Access Compliance Report

Public Rights-of-Way

(Curb Ramps)

Intersection ID: 3955	Main Street: APPLEVALLEY_CT	Cross Street: ARMITAGE_DR	Location: W
ADA ID: E939D835309A	Ramp Type: BlendTrans1	Initial Pass/Fail: Fail	Overall Compliance: No
Severity Score: 42.5			
Codes/Mitigation Info/Possible Solution		Field Measurements/Component Compliance

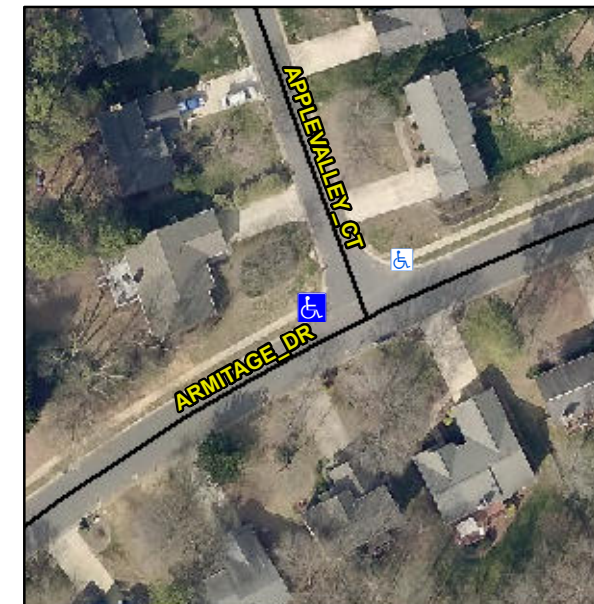
Not Found, R304.5.1, R304.5.3

Compliance	Description	Data	Compliance	Description	Data
N/A	Ramp Length (in)	58.0	Yes	BlendTrans Slope (%)	3.5
No	Ramp Width (in)	35.0	No	BlendTrans XSlope (%)	8.9
N/A	Flare Type LT	N/A	N/A	Flare Type RT	N/A
N/A	Flare Slope LT (%)	N/A	N/A	Flare Slope RT (%)	N/A
N/A	Flare Traversable LT?	N/A	N/A	Flare Traversable RT?	N/A
N/A	Landing Length (in)	N/A	N/A	DWS Provided?	N/A
N/A	Landing Width (in)	N/A	N/A	DWS Contrast?	N/A
N/A	Landing Slope (%)	N/A	N/A	DWS Length (in)	N/A
N/A	Landing X Slope (%)	N/A	N/A	DWS Full Width?	N/A
N/A	Landing Curb? (Y/N)	N/A	N/A	DWS Offset (in)	N/A
N/A	Shared Landing?	N/A			
N/A	Gutter Ponding?	N/A	N/A	Gutter Slope (%)	N/A
N/A	Gutter Lip Ht (in)	N/A	N/A	Gutter X Slope (%)	N/A
N/A	Painted X Walk1?	No	N/A	Painted X Walk2?	N/A
	X Walk 1 Direction	To NE		X Walk 2 Direction	N/A
	X Walk 1 Width (in)	N/A		X Walk 2 Width (in)	N/A
	X Walk 1 Slope (%)	6.3		X Walk 2 Slope (%)	N/A
	X Walk 1 X Slope (%)	4.0		X Walk 2 X Slope (%)	N/A

N/A	Ramp inside XWalk1?	N/A	N/A	Ramp inside XWalk2?	N/A
	Road Slope (%)	4.0		Clear Space?	N/A
	Road X Slope (%)	6.3	N/A	Clear Space to XWalk (in)	N/A
N/A	Any Obstructions?	N/A	N/A	Storm Grate/Utility Hazard?	N/A
	Obstruction Type			Storm Grate/Utility Type	
		N/A			N/A
			Yes	Surface Condition? (G/P)	Good
			No	Curb Slope (%)	18.0

Remove & Replace Curb Ramp With Two New Directional Ramps or Equivalent.
